HISTORIC AND DESIGN REVIEW COMMISSION

March 02, 2022

HDRC CASE NO: 2022-055
COMMON NAME: 1014 N CHERRY
ADDRESS: 1012 N CHERRY
1014 N CHERRY
LEGAL DESCRIPTION: NCB 512 BLK 25 LOT 6 HS
NCB 512 BLK 25 LOT 5 & W 57 FT OF N 52.9 FT OF 10
ZONING: RM-6, H
CITY COUNCIL DIST.: 2
DISTRICT: Dignowity Hill Historic District
APPLICANT: Ricardo Turrubiates/Mint Development LLC
OWNER: Delafield Investments, LLC
TYPE OF WORK: Construction of eight, 2-story residential structures
APPLICATION RECEIVED: January 14, 2022
60-DAY REVIEW: Not applicable due to City Council Emergency Orders
CASE MANAGER: Edward Hall
REQUEST:

The applicant is requesting conceptual approval to construct eight, 2-story residential structures on the vacant lots at 1012 and 1014 N Cherry Street, located within the Dignowity Hill Historic District.

Setback Exhibit

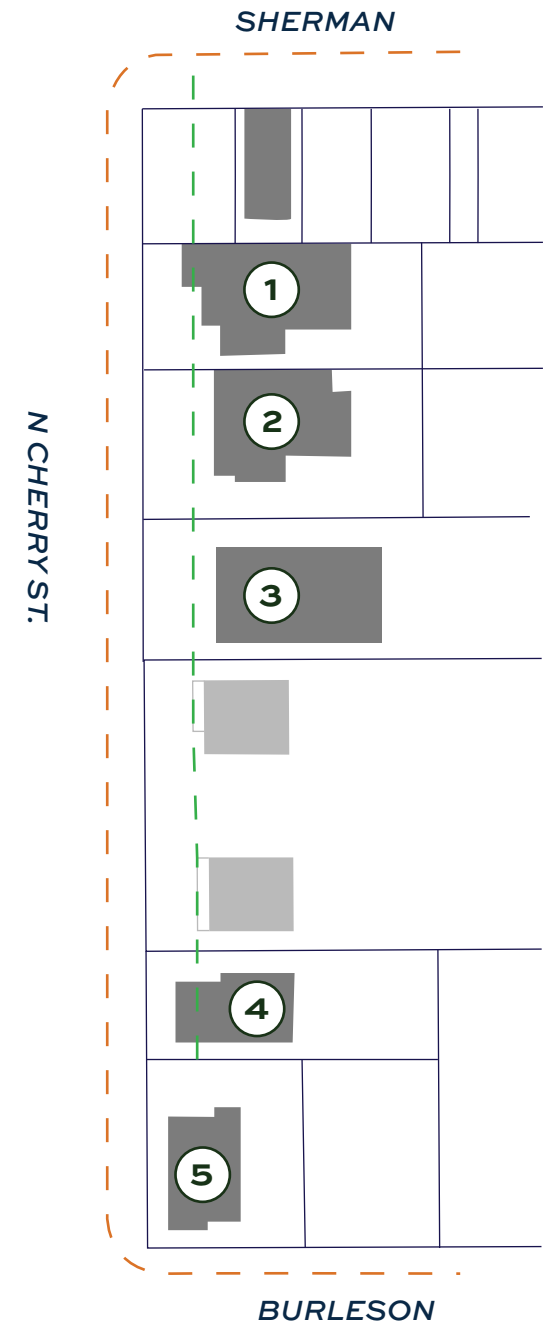
- e. **SETBACKS** – As noted in finding a, the applicant has proposed for two of the eight structures to feature street frontage and an orientation towards N Cherry. The Guidelines recommend that, in instances where front yard setbacks of historic houses are varied on a block face, new construction should feature a front yard setback that is the median of houses on the block face. The applicant has submitted a setback diagram providing the front setbacks of 1010, 1018, 1024, and 1026 N Cherry. The median setback of the four structures oriented towards N

Cherry is approximately thirty-two (32) feet. The applicant has proposed setbacks for the new construction on N Cherry of 30' – 0" and 31' – 5" when measured from the curb. Staff finds that the setback portrayed in the setback diagram is appropriate.

- i. That the site plan be developed to better document conformance with the Guidelines regarding setbacks.
- ii. That the applicant decrease massing on site as noted in finding f. A reduction in building footprint, elimination of proposed buildings, or lowering of height to single story for some structures would be more appropriate.

Lot / Building Coverage Exhibit

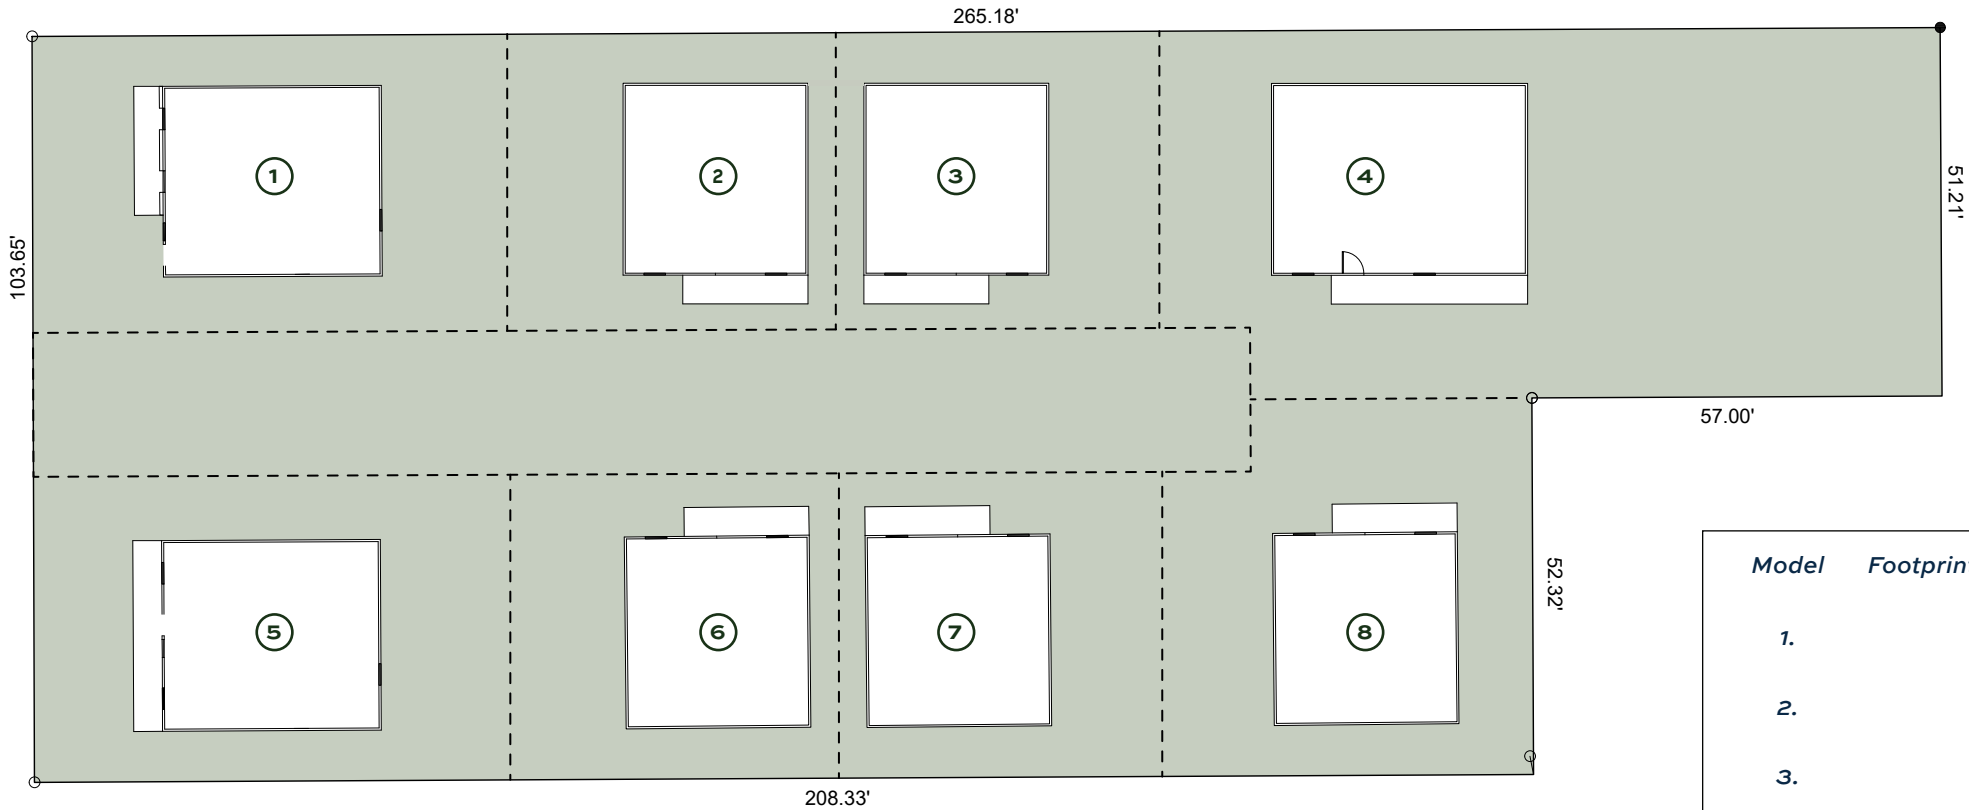
- o. LOT COVERAGE – The applicant has provided a lot coverage diagram noting consistency with the Guidelines for each of the six proposed lots.
- p. PARKING – The applicant has proposed for parking to be located to the interior of the lot, with each structure featuring individual parking to be located to either the east or west of the primary facades. For the front two structures, parking would be located at the rear of each structure. Per the submitted site plan, parking for each structure will be located on a permeable surface. Generally, staff finds the proposed parking to be appropriate.

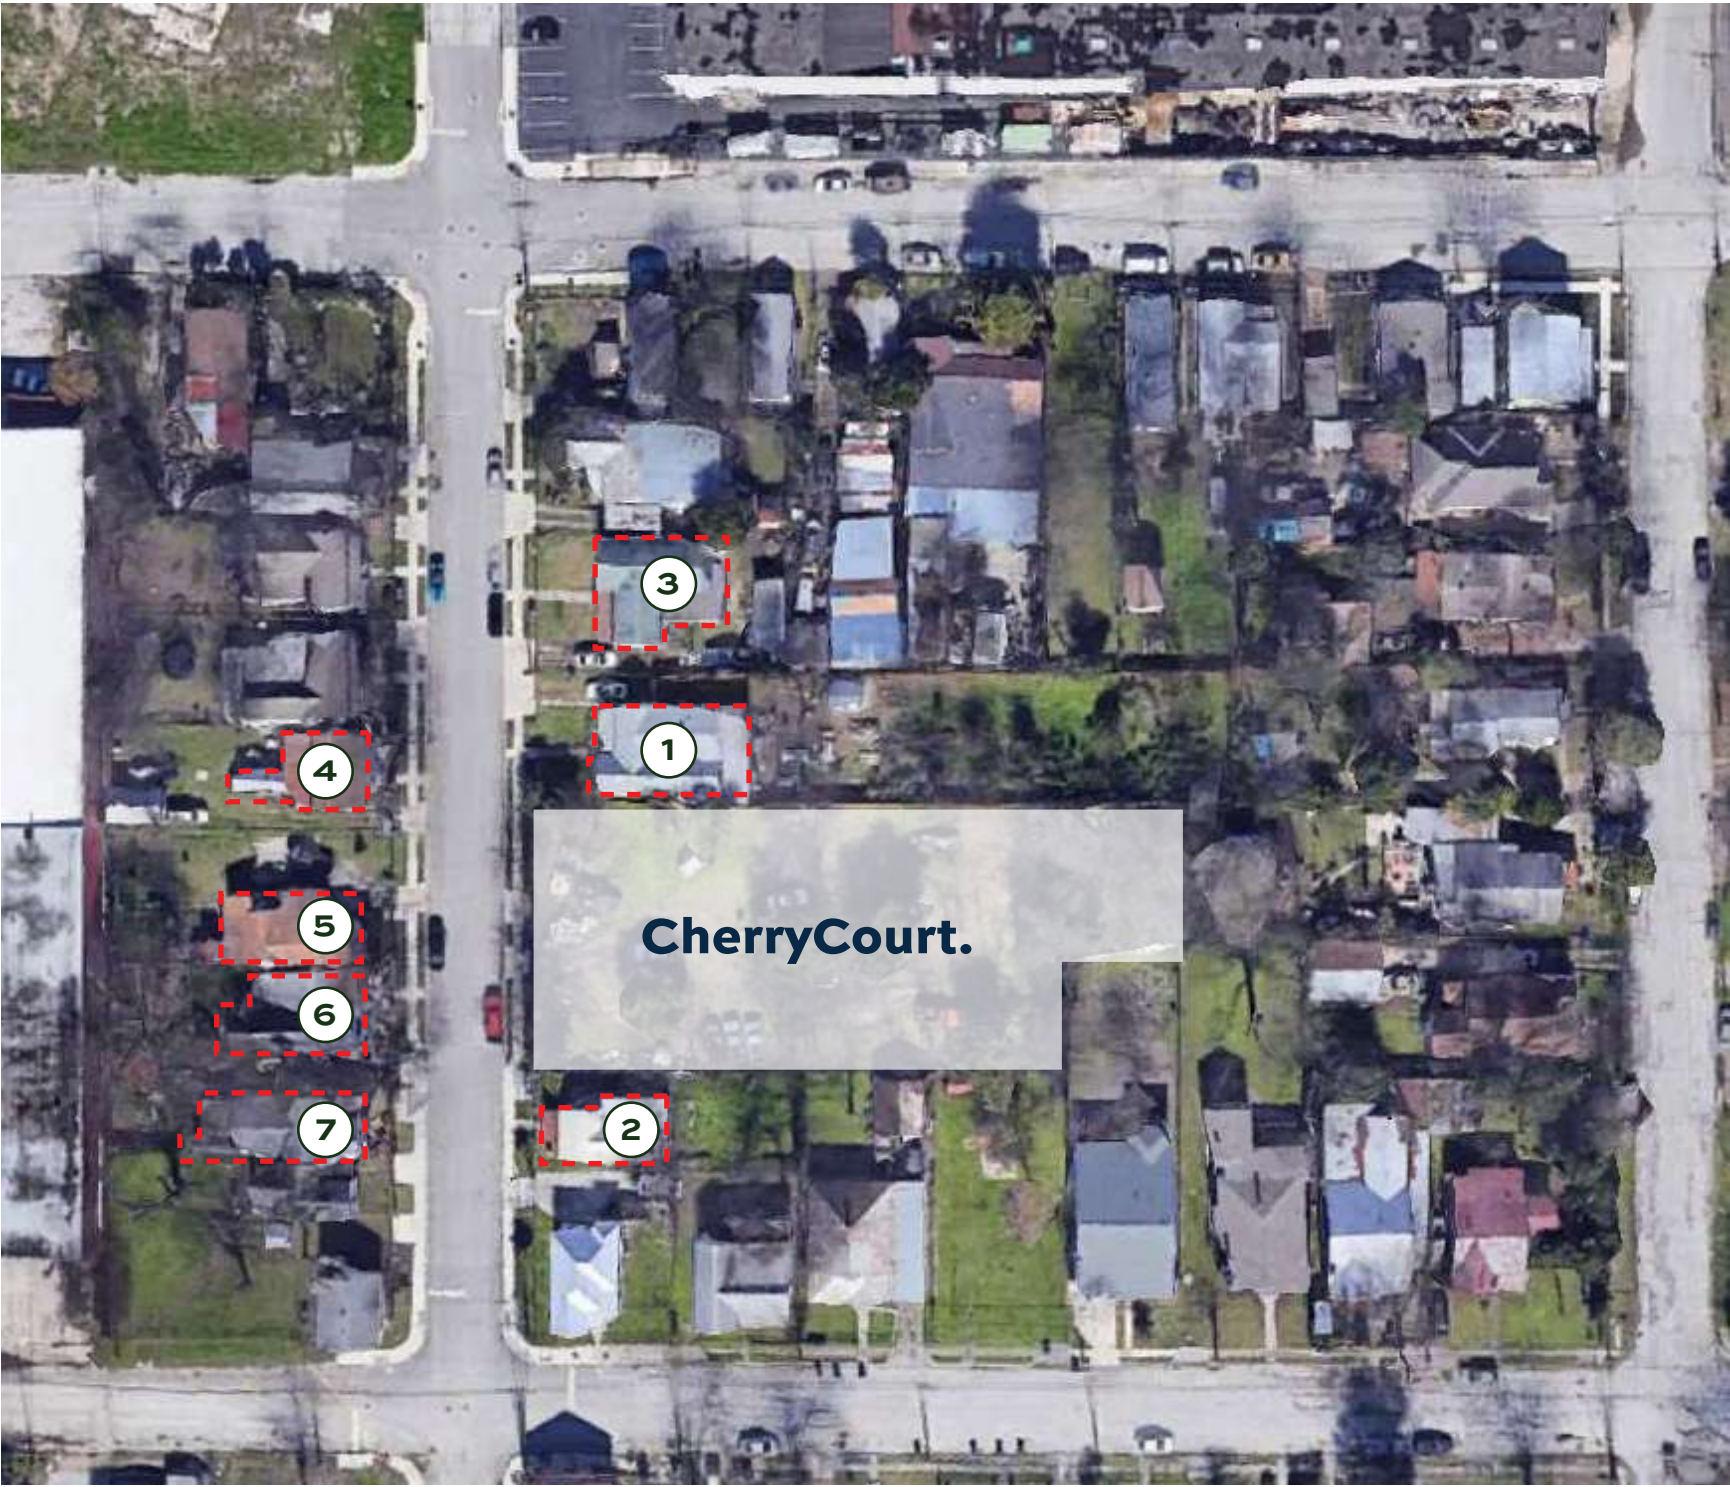
- f. **SCALE & MASS** – Per the Guidelines for New Construction 2.A.i., a height and massing similar to historic structures in the vicinity of the proposed new construction should be used. In residential districts, the height and scale of new construction should not exceed that of the majority of historic buildings by more than one-story. As noted in finding c, all of the existing, historic structures on this block feature one (1) story in height. Generally, staff finds the two story structures fronting N Cherry to be consistent with the Guidelines, as they feature one additional story in height over the existing, historic structures found on the block. However, within historic districts, the historic development pattern features rear structures with massing that is subordinate to that of the primary structure at the street. Staff finds the overall massing to be inconsistent with the Guidelines in regards to height and building footprint, as the historic development pattern throughout the district typically consists of rear structures featuring reduced massing and footprints in comparison to primary, street fronting structures. Additionally, staff finds that the applicant should submit a street elevation noting the proposed heights of new construction in relationship to existing, historic structures.

JF: Proposed massing seems to overwhelm the proposed massing of the adjacent one story historic structures (height and footprints).
